RE: City of Kirkland / Watershed Company review comments for 12833 NE 90th Street.

BUFFER PLANTING PLAN
WEBBER SP
 12833 NE 90TH STREET
 KIRKLAND, WA 98034
 TAX PARCEL NO.: 388870-0100

Re: Webber Short Platt Buffer Modification Proposal Review
12833 NE 90th Street, Kirkland, WA
The Watershed Company Reference Number: 060701.58

Re: Webber Short Plat Revised Buffer Modification Proposal Review
12833 NE 90th Street, Kirkland, WA
The Watershed Company Reference Number: 060701.58

PRELIMINARY UTILITY PLAN			
OWNER		DEL WEBBER 12833 NE 90TH STREET KIRKLAND, WA 98033	
PROJECT SURVEYOR		AXIS SURVEY AND MAPPING 13005 NE 128TH PLACE, KIRKLAND, WA 98034 PHONE: (425) 823-5700 FAX: (425) 823-6700	
SCALE	PROJECT NO.	SHEET	
AS NOTED	0100-13-101	2 of 4

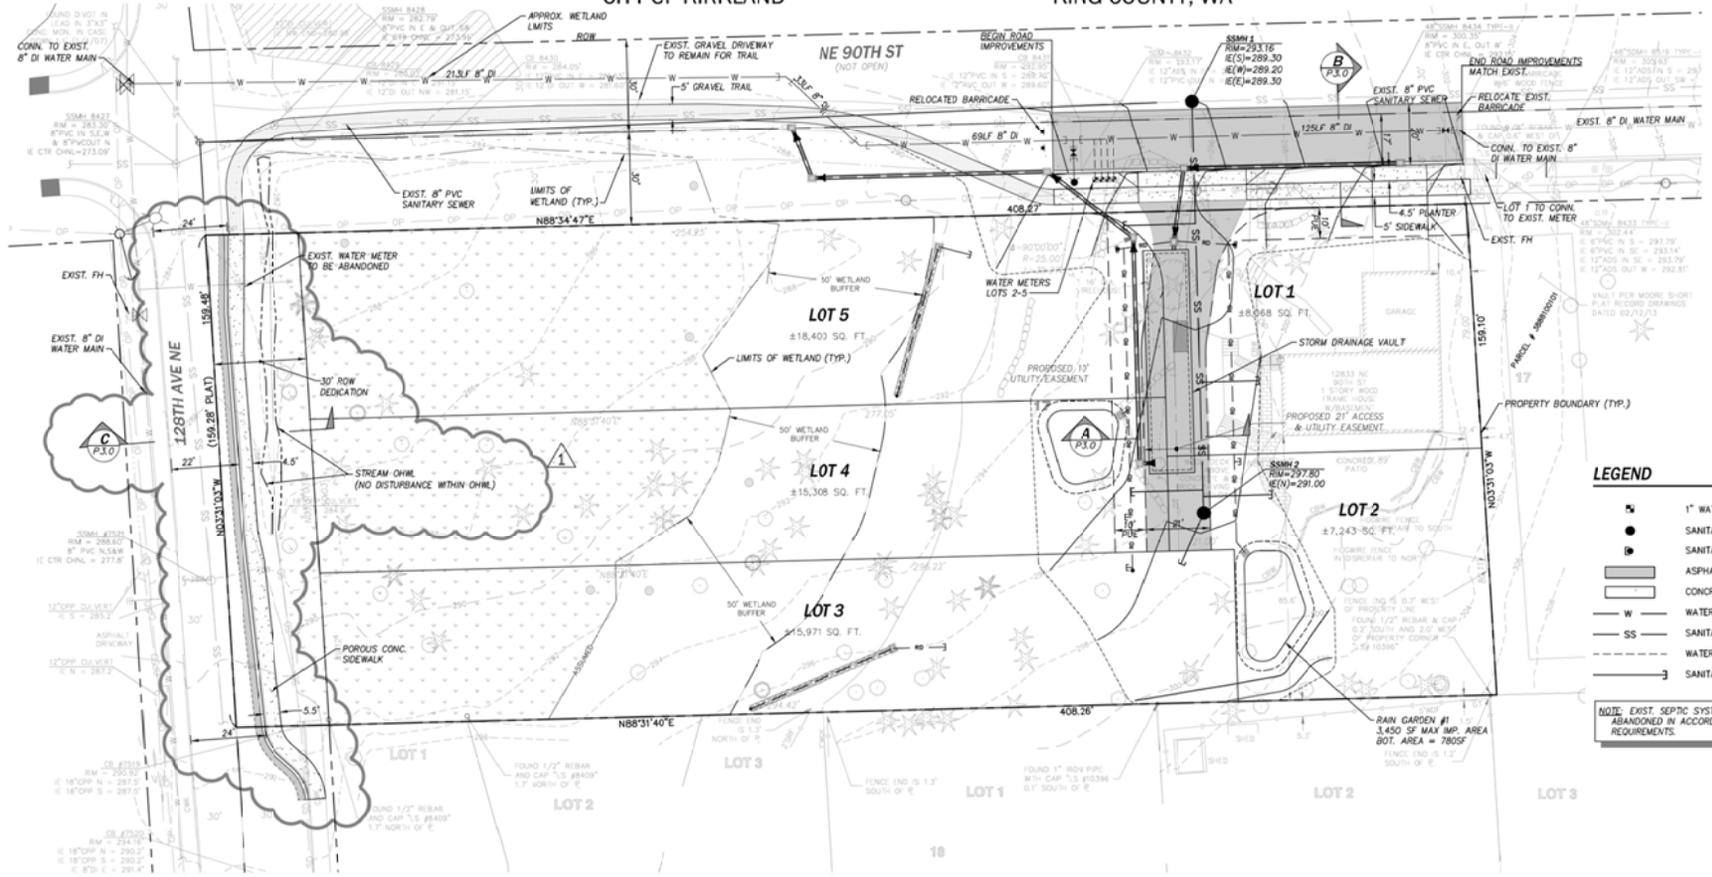
4. Provide additional plans or cross sections showing utility conflicts and required separation. If all utilities can fit within the roadway, revise the plans to eliminate the wetland buffer impact on the north side of the gravel road.

Utilities are proposed along the north edge of the gravel road in the NE 90th Street ROW. There is a one-sentence explanation about conflicts with the existing infrastructure and separation requirements for utilities. More information is needed to understand what infrastructure conflicts and which utilities require separation distances. In addition to meeting mitigation sequencing requirements in 90.20, lowering the buffer impact would also reduce the overall cost of the mitigation plan installation, monitoring and maintenance.

The existing sewer line and storm drain have been depicted on the Buffer Mitigation Plan for Webber Short Plat prepared by *Acre Environmental Consulting, LLC* and dated November 3, 2014 Revision #1. A discussion of the separation requirements and justification for the proposed water line location has been included in the Project Description section of this plan.

B TYPICAL ROAD SECTION - NE 90TH STREET
 P2.00 NOT TO SCALE

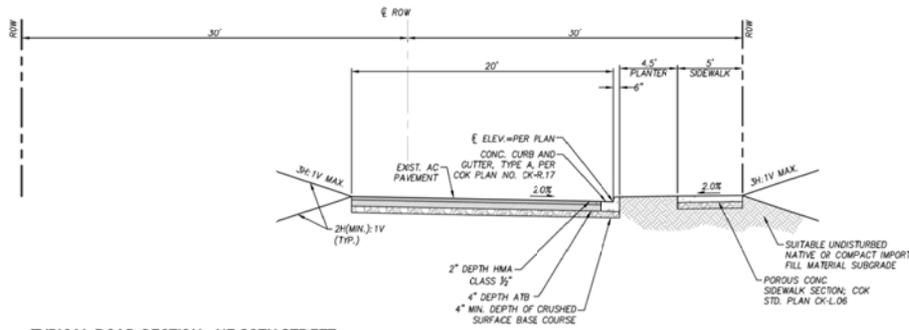
- 1. Revise the submittal to include pervious pavement for the sidewalk portion located within the wetland buffer. Provide a cross sectional drawing showing the sidewalk in relation to the stream.***

Sheet W-1 shows a new section of sidewalk along 125th Avenue NE. The plan acknowledges this will result in an additional 713 square feet of impervious area. Sidewalks may be located in wetland buffers under KZC 90.20.4. However, this section requires demonstration of no alternative location for the impact and also requires no increase in impervious surface area or reduced flood storage capacity. There is no allowance for mitigating this increase in impervious area through the use of additional detention, as proposed. Also, a cross section showing the sidewalk and its relationship to the Class B stream would be helpful in understanding the proposed relationship of these features. During the site visit, it appeared there is very little room for the sidewalk between the stream channel and the current edge of pavement.

To ensure that impervious areas within the buffer are not increased as required by KZC 90.20.4, the applicant has agreed to use pervious pavement to construct the 713 square feet of sidewalk proposed within the buffer. Use of pervious concrete is discussed both on the Acre plan and on the engineer's plans. A cross sectional drawing showing the proposed sidewalk in relation to the stream has been prepared by the project engineer, CPH Consultants and can be seen in the Typical Road Section detail on the Roadway Sections plan attached to the Acre Sheets W1 and W2.

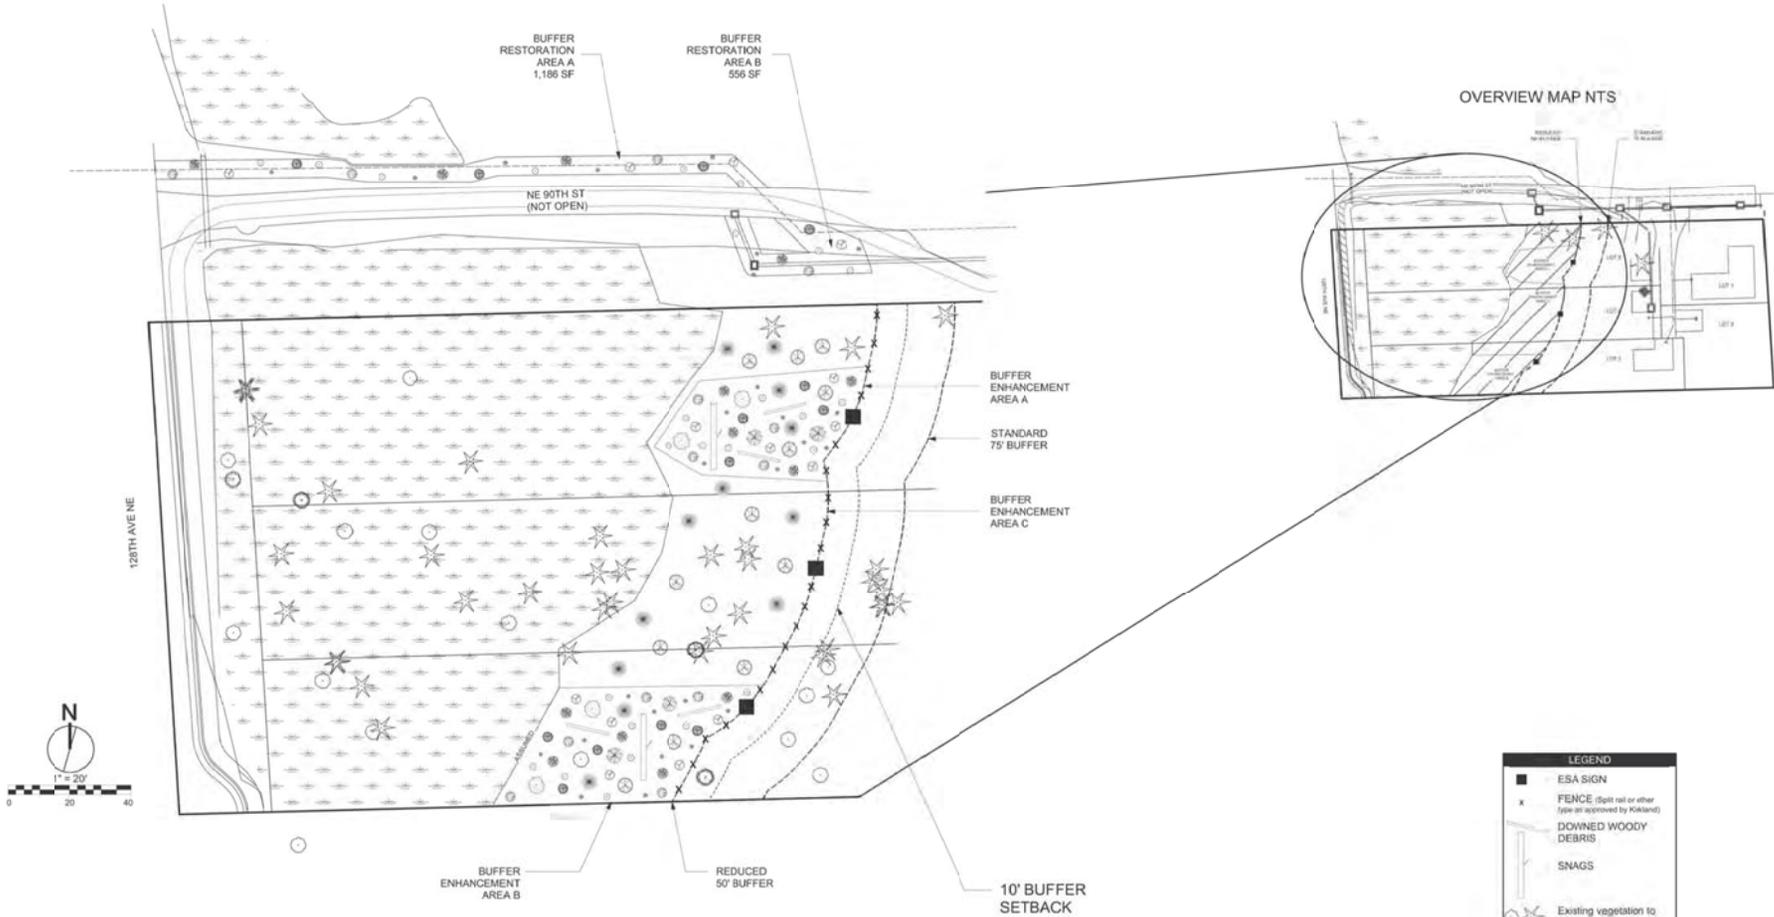
3. Revise the planting plan to avoid future conflicts with overhead power lines.

There are three bigleaf maples and six Douglas-fir trees (three plants per symbol) proposed very near the overhead power lines along the northern property line. These trees should be moved farther south to avoid future power line conflicts or they should be replaced with lower-growing species.

The Buffer Planting Plan for Webber Short Plat prepared by *Acre Environmental Consulting, LLC* has been revised and dated Revision 1, November 3, 2014. On this plan, the three big-leaf maple and six Douglas fir have been relocated south of the power line easement.
